DEPARTMENT OF TRANSPORTATION**Federal Aviation Administration****14 CFR Part 39**

[Docket No. 98–SW–33–AD; Amendment 39–11460; AD 98–25–10 R1]

Airworthiness Directives; Aircraft Belts, Inc. Model CS, CT, FM, FN, GK, GL, JD, JE, JT, JU, MD, ME, MM, MN, NB, PM, PN, RG, and RH Seat Restraint Systems

ACTION: Final rule.

Figure 1

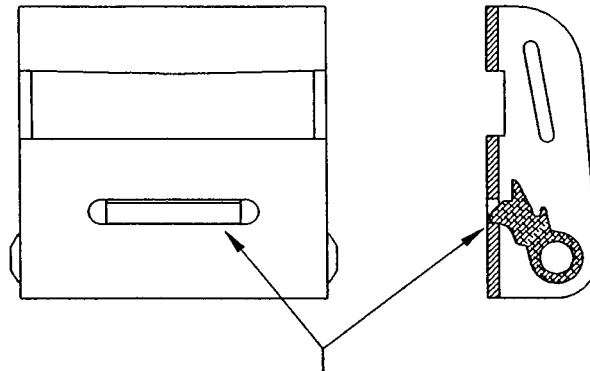
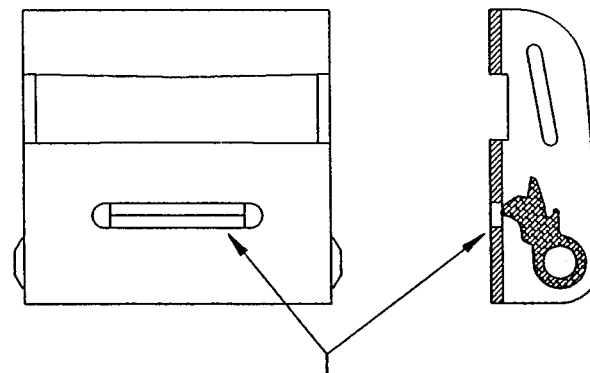
(a) Visually check all affected seat restraint systems to determine if the locking mechanism is engaging properly in accordance with the following:

(1) Open the lift lever of the buckle fully until it will not open any further. This will cause the locking mechanism to pivot on the pivot pin.

(2) Allow the spring to close the lift lever slowly until the lift lever is back to its at-rest position.

(3) After the lever is completely closed, examine the slot in the bottom of the buckle. The locking mechanism should be firmly seated against the edge of the slot as shown in Figure 1.

RIGHT

THE LEDGE OF THE LOCKING MECHANISM MUST BE FIRMLY SEATED ON THE BOTTOM EDGE AS SHOWN.

WRONG

THE LEDGE OF THE LOCKING MECHANISM IS NOT FIRMLY SEATED ON THE BOTTOM EDGE,

(b) If the locking mechanism does not seat properly, replace the buckle with an airworthy buckle.
